SECTION 4.55(1A) MODIFICATION APPLICATION WAGGA WAGGA BASE HOSPITAL, CORNER OF EDWARD AND DOCKER STREET, WAGGA WAGGA

This application has been prepared by Ethos Urban on behalf of NSW Health Infrastructure, pursuant to Section 4.55(1A) of the *Environmental Planning and Assessment Act 1979* (EP&A Act) to modify Development Consent SSD 9033 relating to the Stage 3 Redevelopment of the Wagga Wagga Rural Referral Hospital, located on the corner of Edward Street and Docker Street, Wagga Wagga (the site).

Figure 1 The approved (top) and proposed (bottom) design and extent of basement carpark Source: Jacobs

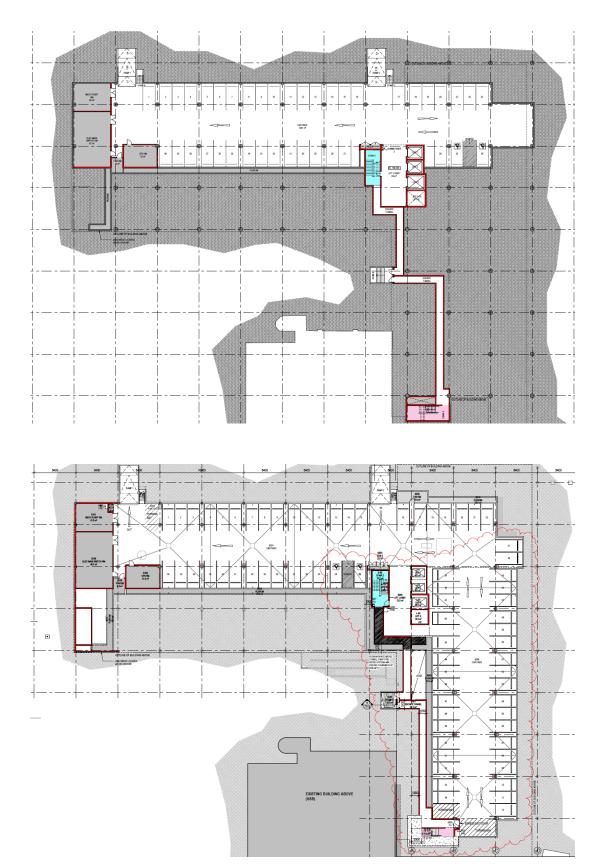
The proposed modification involves amendments to the extent and design of the basement carpark approved under SSD 9033. This will involve additional excavation beneath the eastern portion of the approved Ambulatory Care Building. The proposed extension of the basement carpark will provide an additional 32 car parking spaces, increasing the total on-site car parking supply of the Wagga Wagga Rural Referral Hospital from 540 to 572 spaces.

To accommodate the extension of the basement car park, the following modifications to the design of the approved basement are proposed:

- · Installation of air handling mechanical plant;
- · Extension and rationalisation of plenum air exhaust; and
- Minor realignment of the fire escape passage.
